# Minor Development Final Plat Staff Report

**Date:** February 18, 2026  
**To:** Douglas County Planning Commission  
**From:** Mike Pesicka, Principal Planner *MP*  
Jeanette Bare, AICP, Current Planning Manager *SK for JB*  
Steven E. Koster, AICP, Assistant Director of Planning Services *SK*  
**Subject:** Pinery Village Filing 2, Minor Development Final Plat  
**Project File:** SB2021-049

The request is for approval of Pinery Village Filing 2, a minor development final plat to create three new commercial lots for future development and seven tracts for drainage, open space, and public right-of-way on 87.85 acres. Further Replats and Site Improvement Plan applications are anticipated in the near future.

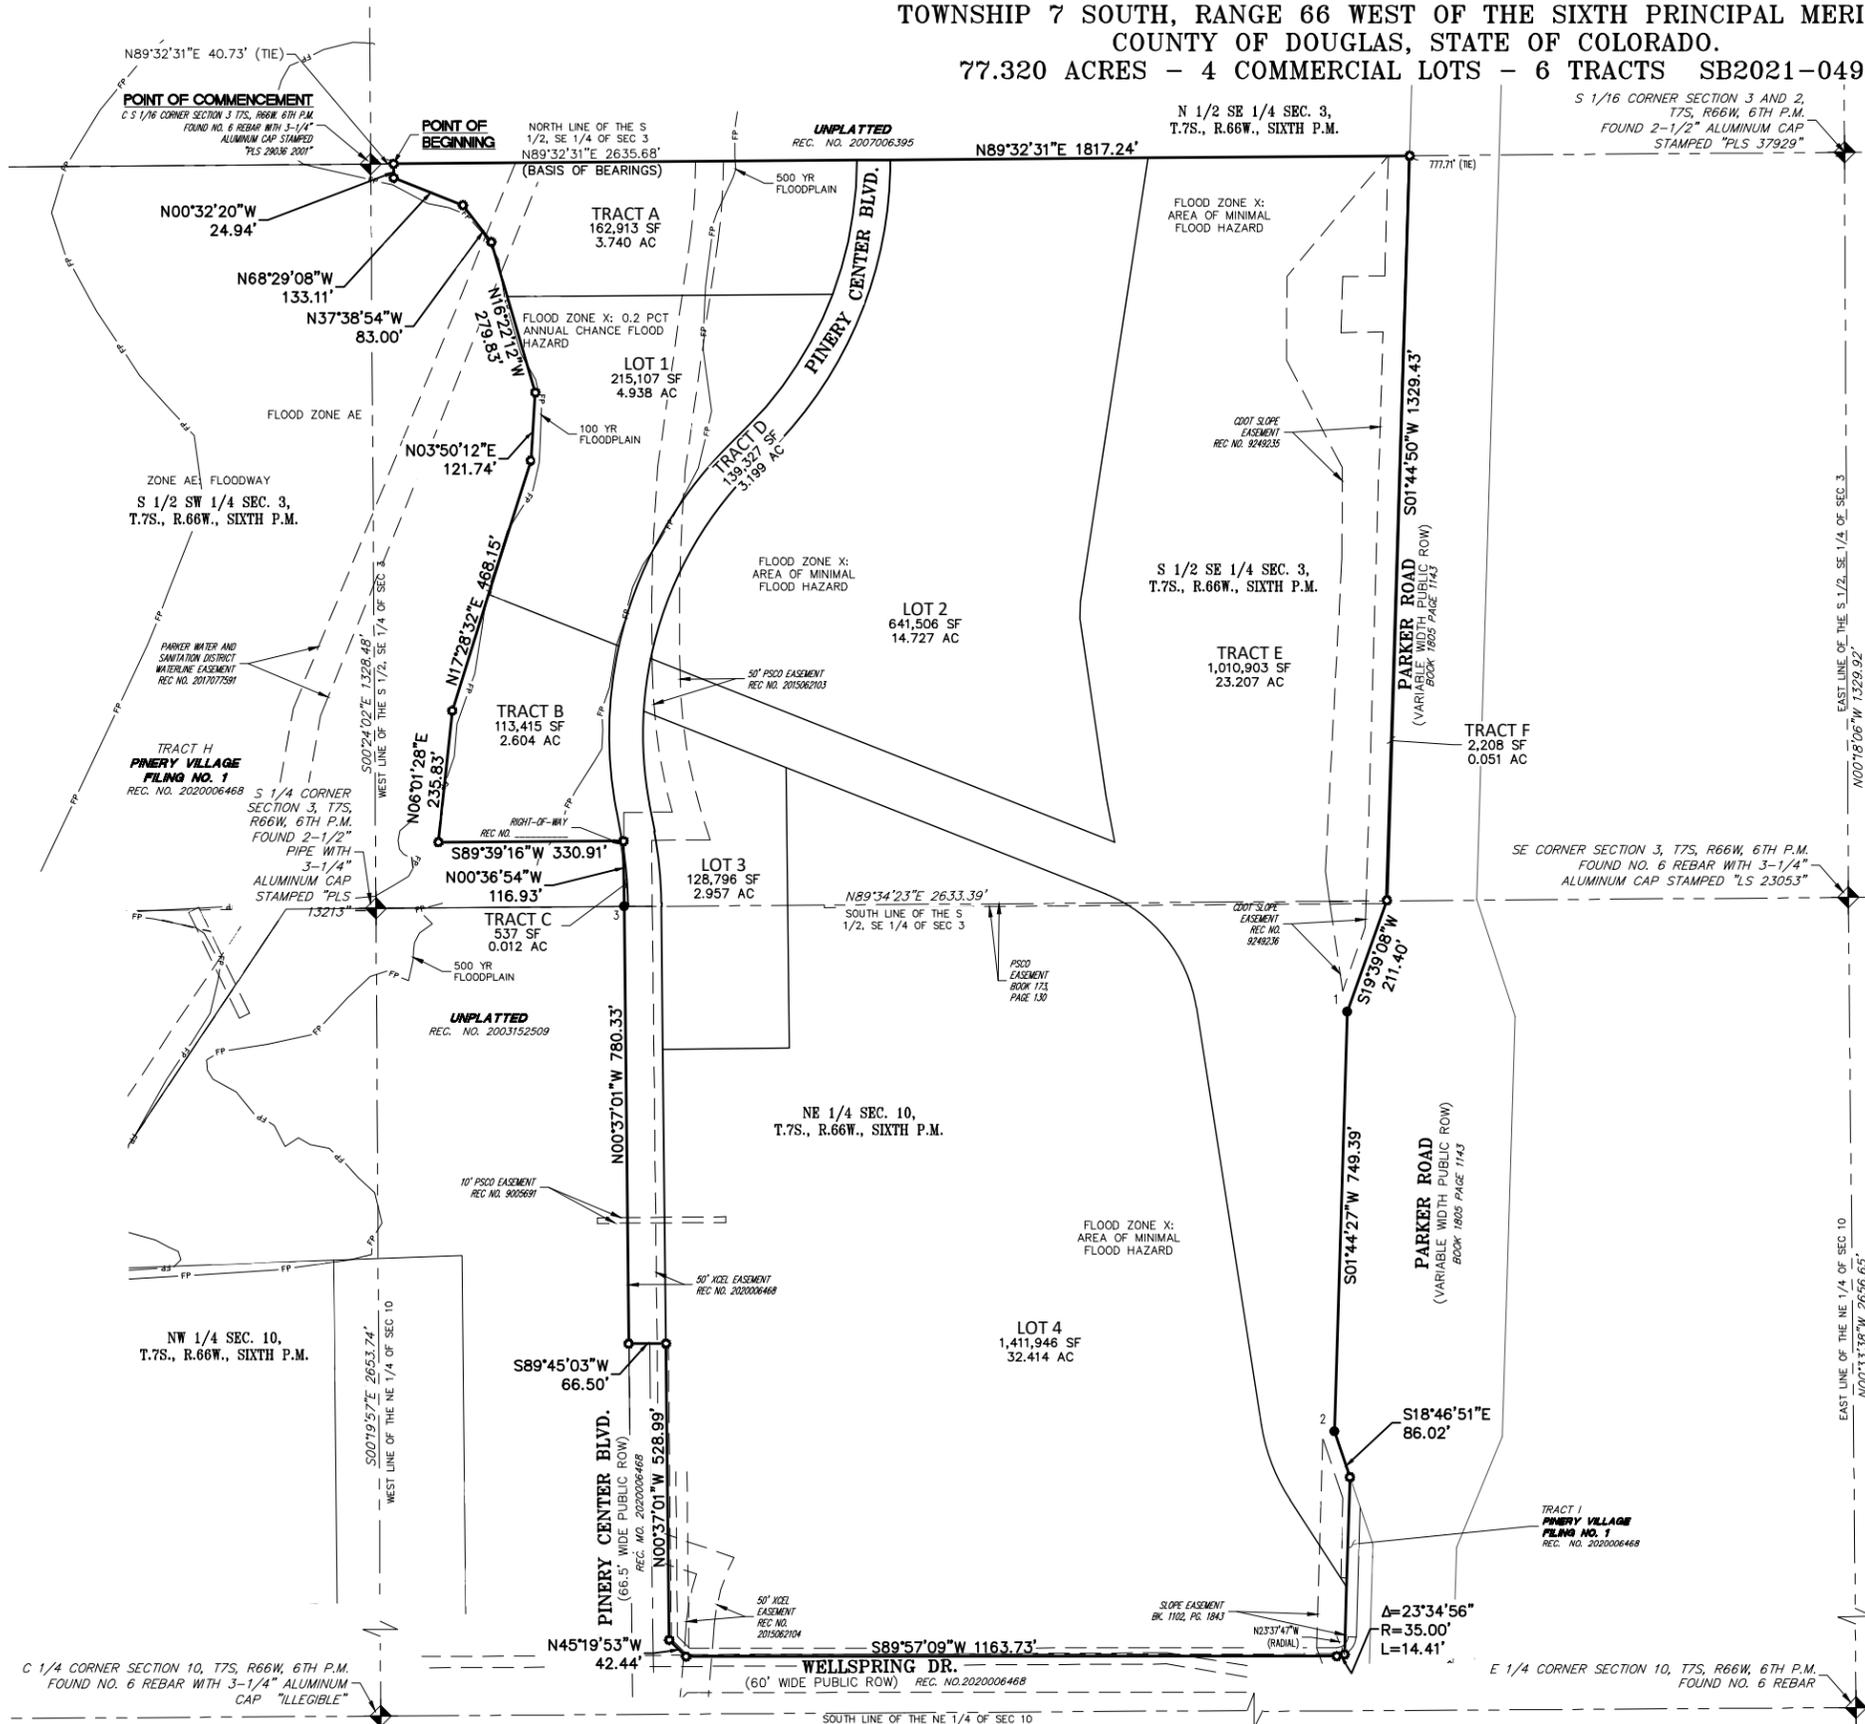
**Comment #1-**On sheet 1, it appears the Dedication Statement and Board of County Commissioners Certification are missing information. There is right-of-way being dedicated, easements, etc.

**Response:** Both statements: Dedication and Board of County Commissioners have been added to the Cover Sheet.
2. *On sheet 2, please clarify why the extension of Pinery Center Blvd. is in a Tract.*

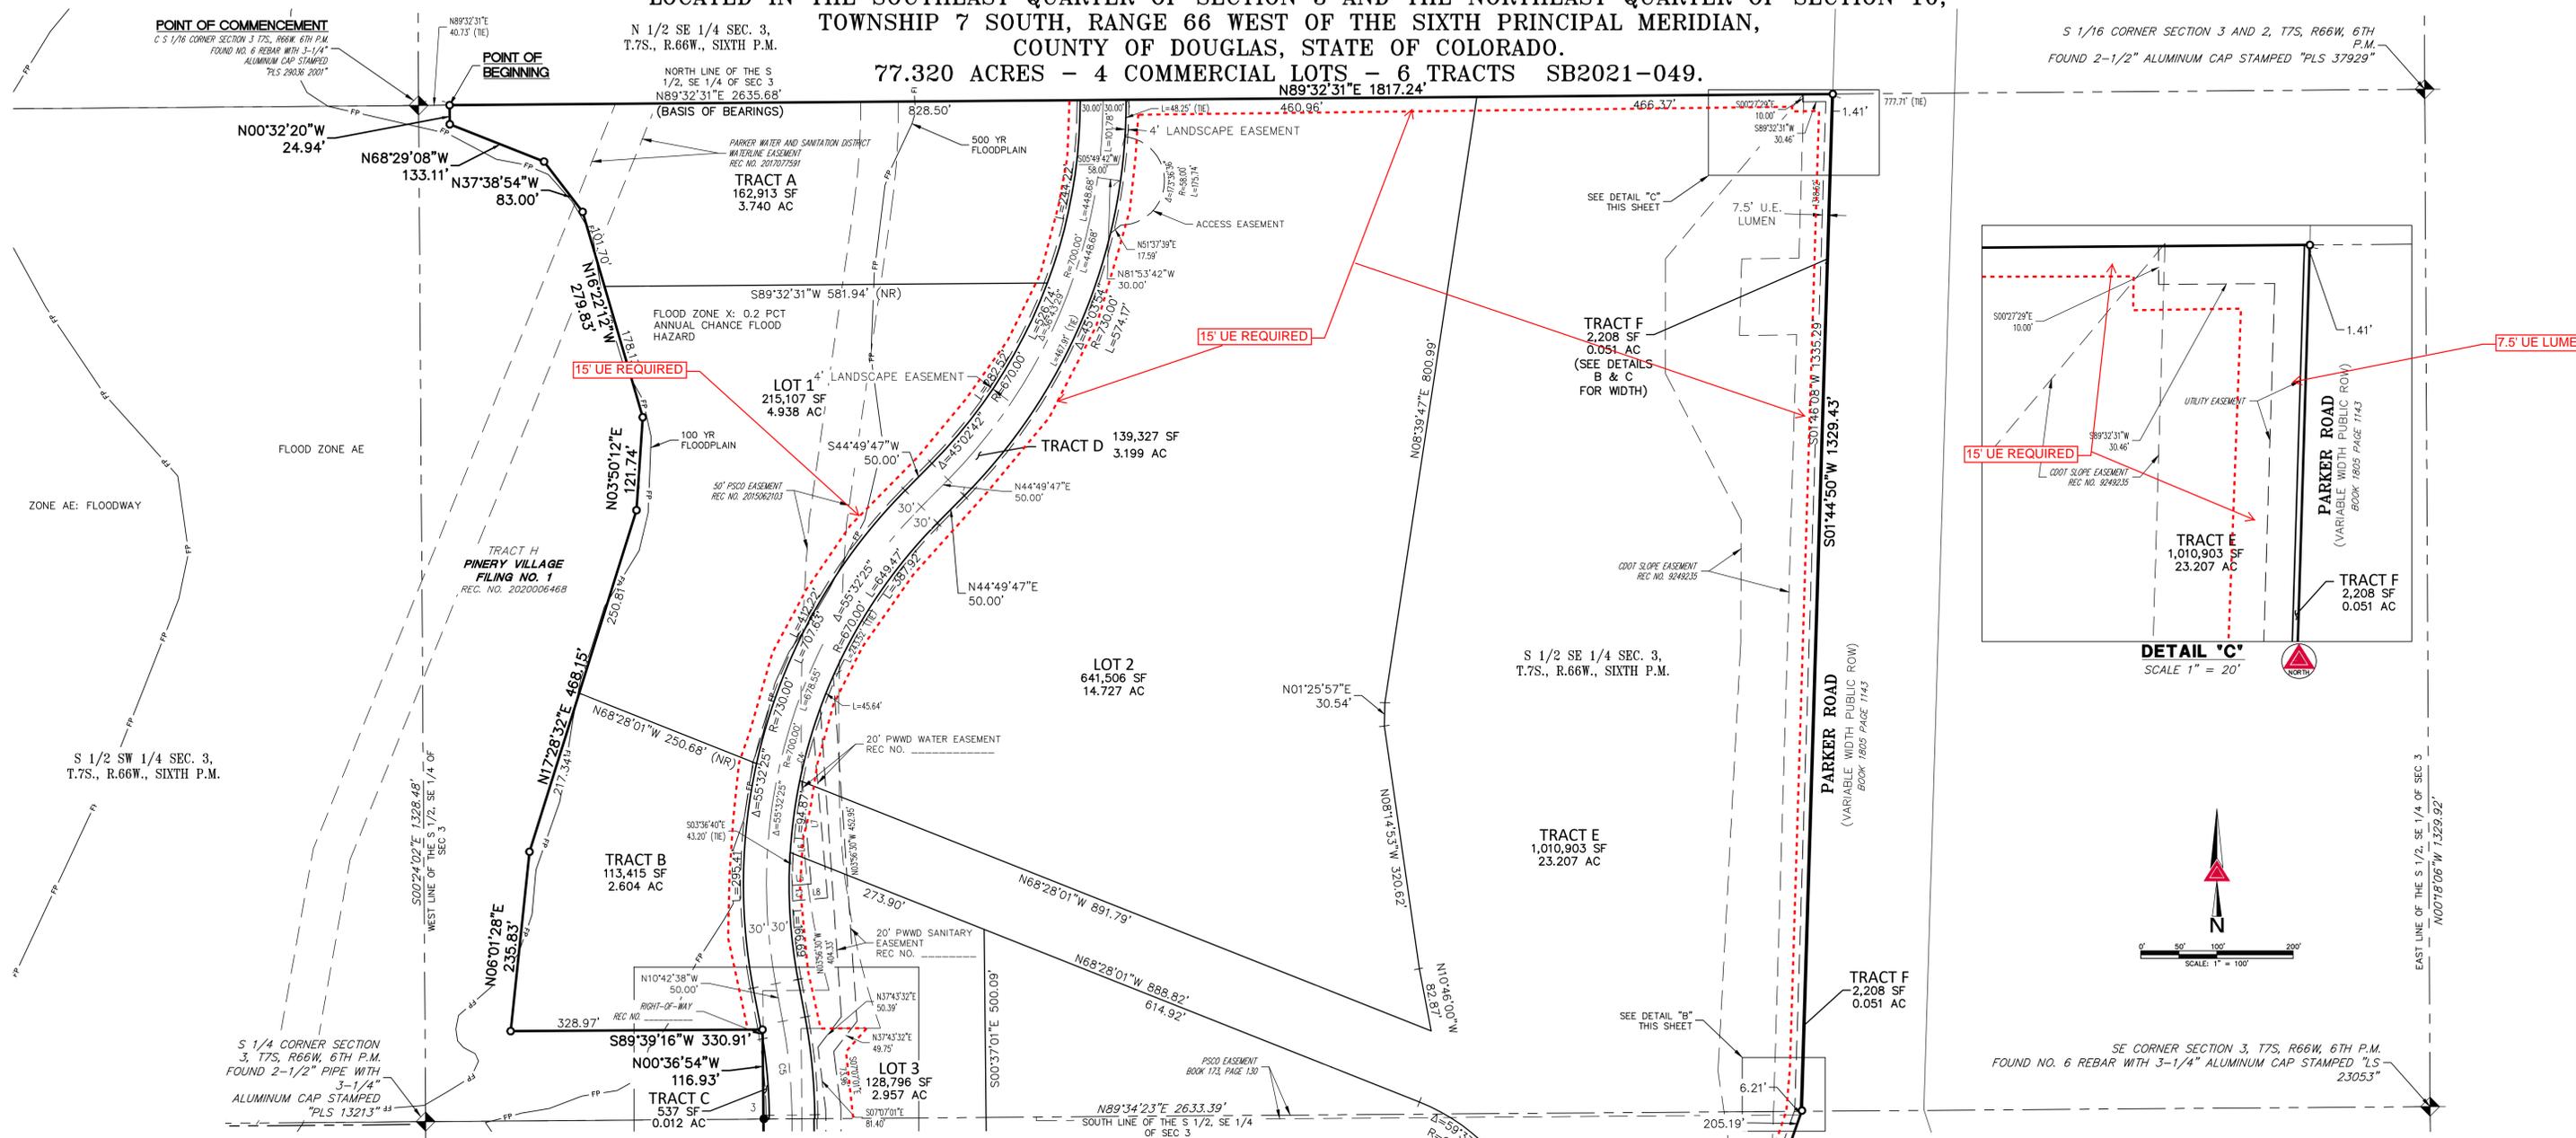
**Comment #2-**On sheet 2, please clarify why the extension of Pinery Center Blvd. is in a Tract.

5. *There is a missing dimension on the subdivision boundary on Sheet 2, the southeastern-most call 316.60 ft call is not dimensioned.*

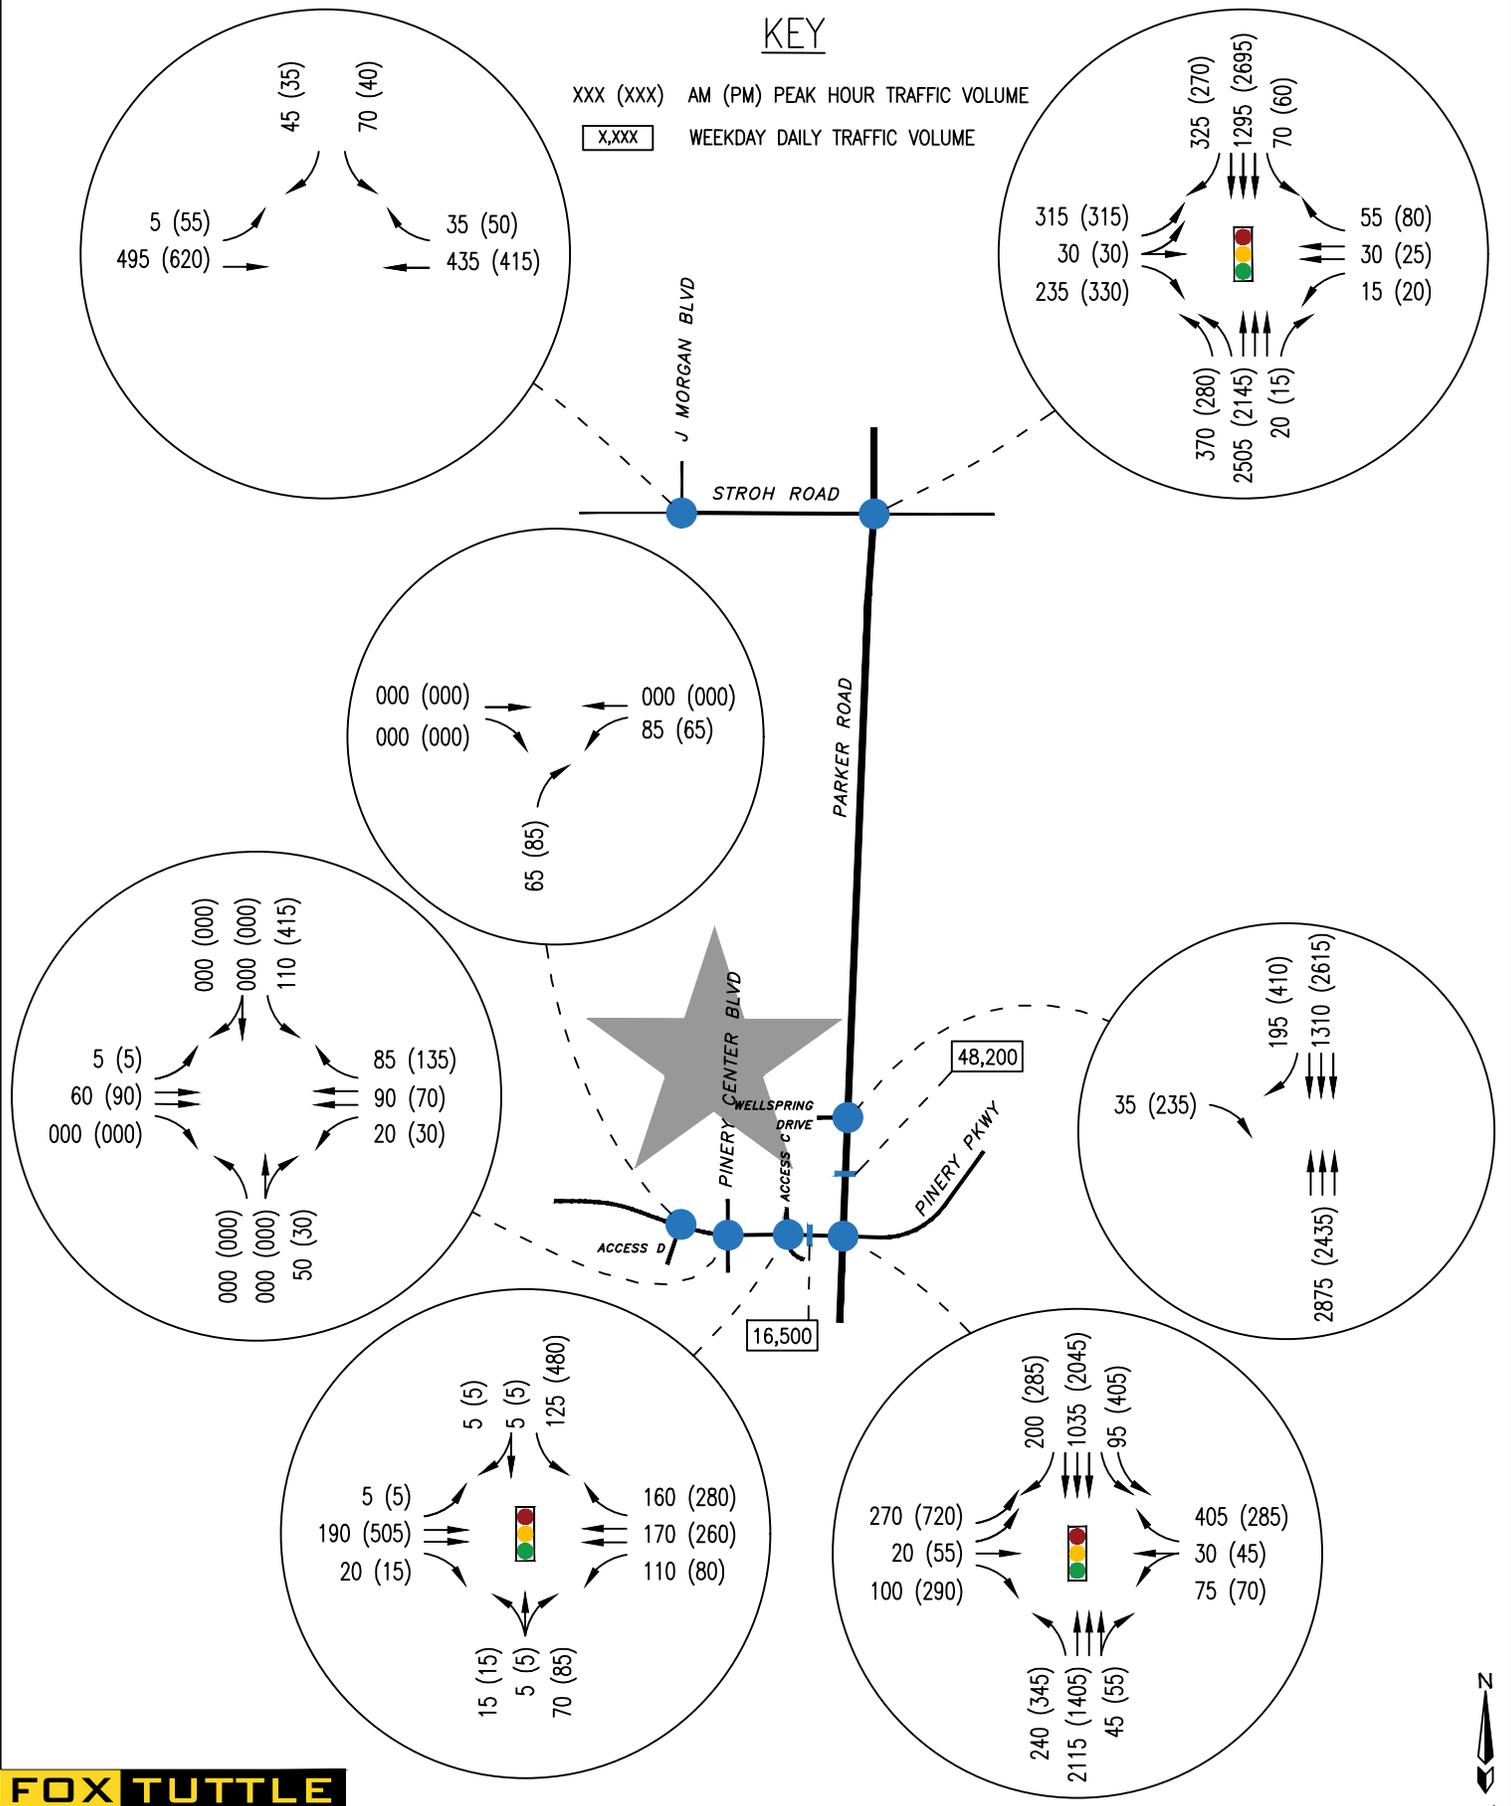
7. *I do not believe less traffic will occur on the SB to EB Left urn movement between 2030-40. The study's figure 10 & 11 is peculiar showing a drop from of peak hour left turns from 405 to 330.*

4. *Applicant needs to review Figures 10 and 11 in the traffic study that project less traffic will occur on the SB to EB left turn movement between 2030-40.*  
**Response:** When Pinery Parkway is extended to the west to Crowfoot Valley Road, as well as when the project is developed and attracts retail/commercial trips that are currently to/from the north towards the Town of Parker, some traffic from the Pinery (east of the project) is anticipated to redistribute from Parker Road to this connection, resulting in decreases to some movements (including the SB left-turn).
